Project	IEEE 802.16 Broadband Wireless Access Working Group < http://ieee802.org/16 >	
Title	CDMA Initial Ranging in OFDMA PHY	
Date Submitted	2005-04-28	
Source(s)	Tal Kaitz, Ran Yaniv Alvarion Ltd.	tal.kaitz@alvarion.com ran.yaniv@alvarion.com
Re:	Call for comments, maintenance task group	
Abstract		
Purpose		
Notice	This document has been prepared to assist IEEE 802.16. It is offered as a basis for discussion and is not binding on the contributing individual(s) or organization(s). The material in this document is subject to change in form and content after further study. The contributor(s) reserve(s) the right to add, amend or withdraw material contained herein.	
Release	The contributor grants a free, irrevocable license to the IEEE to incorporate material contained in this contribution, and any modifications thereof, in the creation of an IEEE Standards publication; to copyright in the IEEE's name any IEEE Standards publication even though it may include portions of this contribution; and at the IEEE's sole discretion to permit others to reproduce in whole or in part the resulting IEEE Standards publication. The contributor also acknowledges and accepts that this contribution m

Figure 4 – Comparison of the current single code scheme with the proposed one, PUSC permutation.

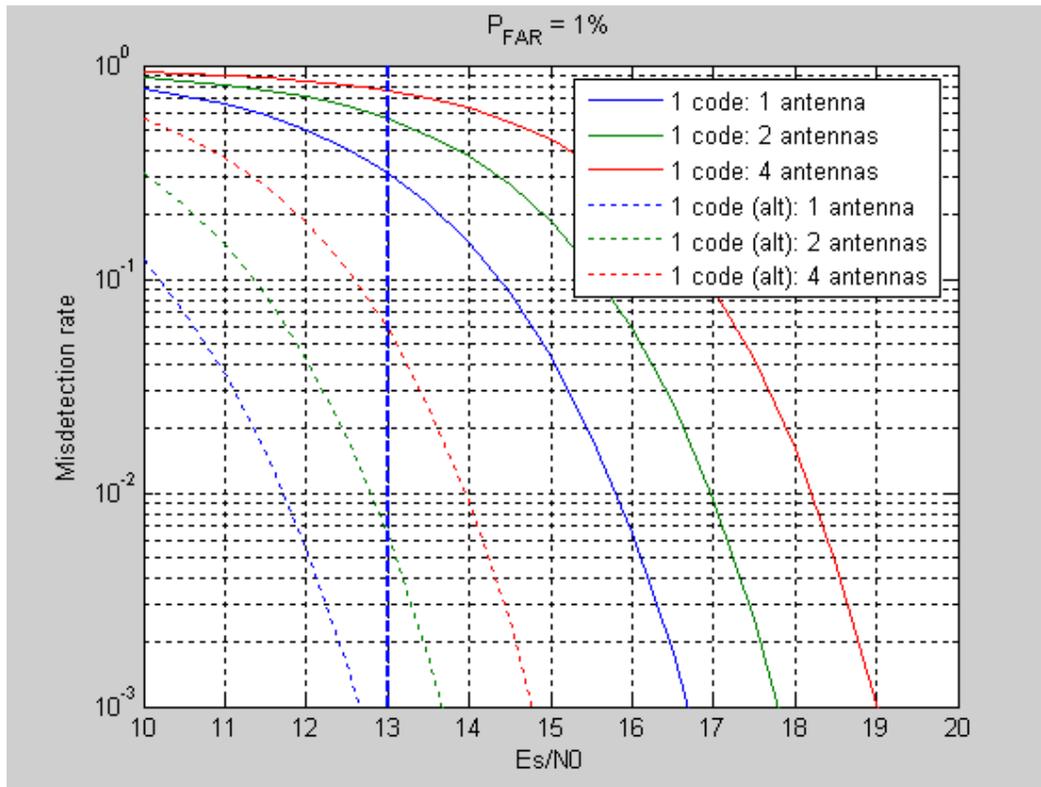
The figure below compares the misdetection rate of the proposed single-code scheme with the current single-code scheme, for PUSC ('1 code (alt)' refers to the proposed scheme).

For the same misdetection rate, the alternative 1-code scheme provides a gain of 4dB relative to the current scheme, occupies the same frequency-time resources, and still maintains a high frequency diversity order.

Figure 5 – Comparison of the current single code scheme with the proposed one, Optional PUSC permutation.

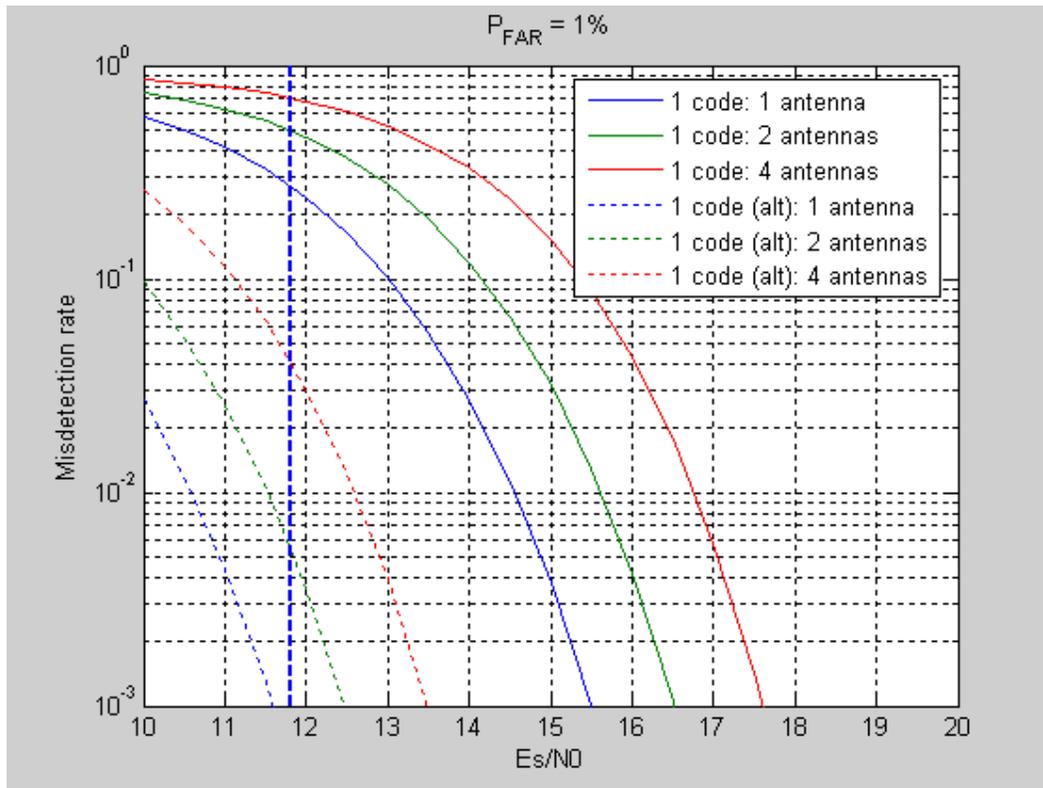
The figure below makes the same comparison for Optional PUSC.
